Access Compliance Report

Public Rights-of-Way

Intersection ID: 23642	Main Street: CASTLEGATE_DR	Cross Street: HEATHERFORD_DR	Location: NE
ADA ID: B80724E1E49A	Ramp Type: Directional1	Initial Pass/Fail: Fail	Overall Compliance: No
		Severity Score: 10

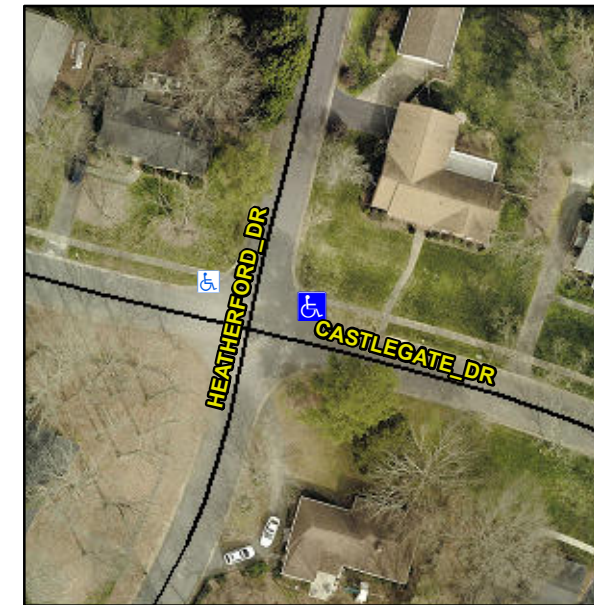
R304.5.1, R304.5.3

Compliance	Description	Data	Compliance	Description	Data
N/A	Ramp Length (in)	28.0	N/A	Grade Break?	N/A
No	Ramp Width (in)	47.5	N/A	Grade Break Slope (%)	0.0
Yes	Ramp Slope (%)	6.3	N/A	Grade Break XSlope (%)	0.0
No	Ramp XSlope (%)	4.2			
N/A	Flare Type LT	N/A	N/A	Flare Type RT	N/A
N/A	Flare Slope LT (%)	N/A	N/A	Flare Slope RT (%)	0.0
N/A	Flare Traversable LT?	N/A	N/A	Flare Traversable RT?	N/A
N/A	Landing Length (in)	0.0	N/A	DWS Provided?	N/A
N/A	Landing Width (in)	0.0	N/A	DWS Contrast?	N/A
N/A	Landing Slope (%)	0.0	N/A	DWS Length (in)	N/A
N/A	Landing X Slope (%)	0.0	N/A	DWS Full Width?	N/A
N/A	Landing Curb? (Y/N)	N/A	N/A	DWS Offset LT (in)	N/A
N/A	Shared Landing?	N/A	N/A	DWS Offset RT (in)	N/A
N/A	Gutter Ponding?	0.0	N/A	Gutter Slope (%)	N/A
N/A	Gutter Lip Ht (in)	0.0	N/A	Gutter X Slope (%)	N/A
N/A	Painted X Walk1?	No		Road Slope (%)	1.5
	X Walk 1 Direction	To W		Road X Slope (%)	3.5
	X Walk 1 Width (in)	N/A		Clear Space?	N/A

Remove & Replace Entire Ramp.
